Origination Form
Proposed Revisions to a Standard Plans Index

Originator:	Turley, Joshua	Index Number:	455-060
Date:	5/15/2025	Sheet Number(s):	Sheet 1
E-mail:	Joshua.Turley@dot.state.fl.us	Index Title:	60" PRESTRESSED CONCRETE CYLINDER PILE

ELEVATION

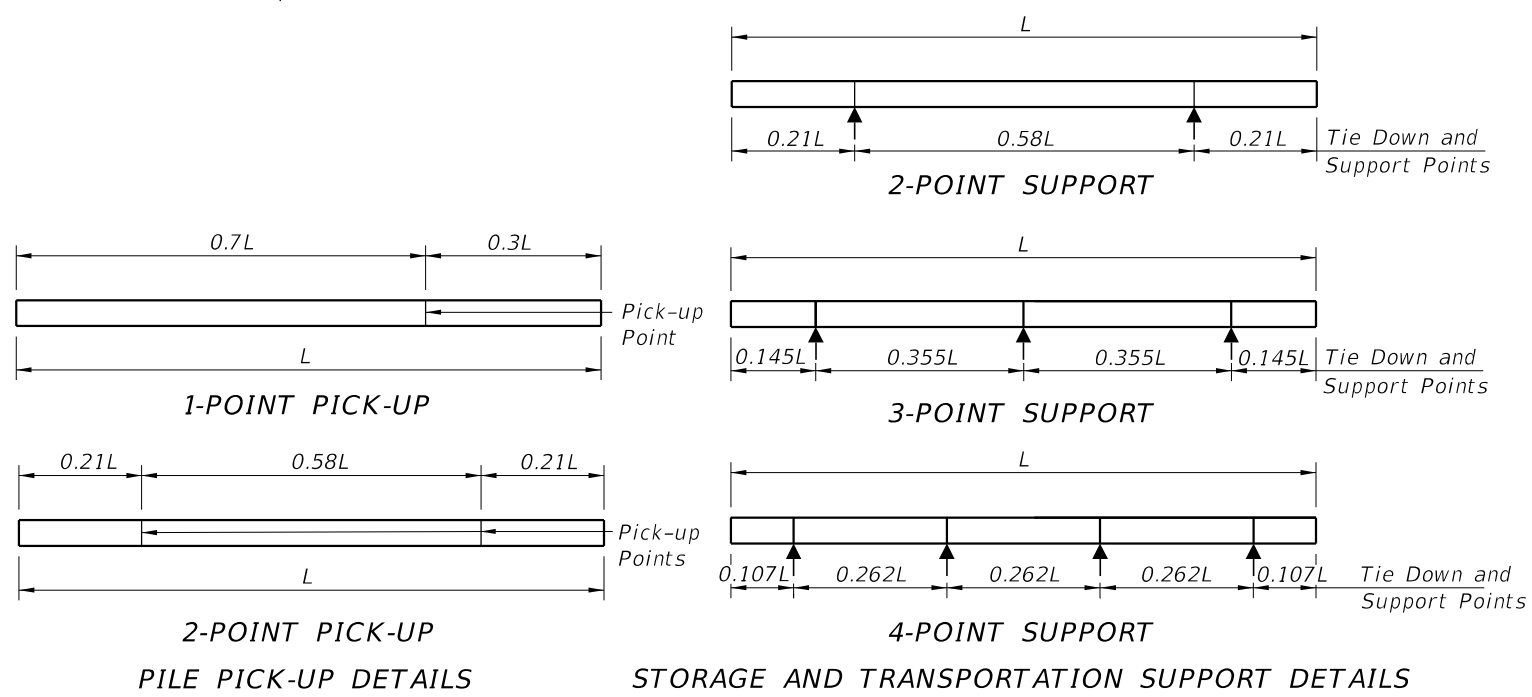
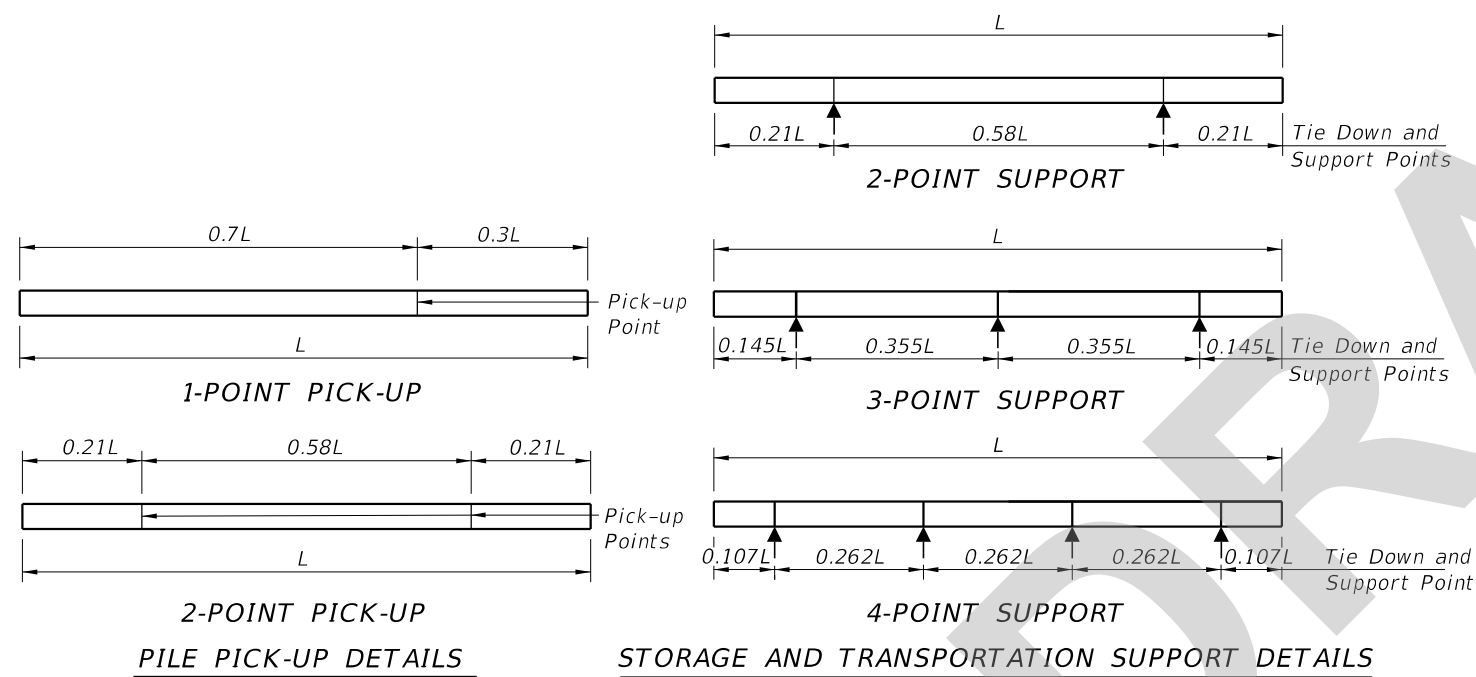
Sheet 1: Changed the pitch spacing of the stirrups in the ELEVATION.

Vertical cracking has been observed in hollow core prestressed concrete piles, including 30-in. voided square HMC and conventional piles, and 60-in. hollow cylindrical piles, during installation and service. To address cracks frequently occur within the 4" stirrup pitch zone, a reduction in stirrup pitch to 2" is proposed to help mitigate cracking in these areas.
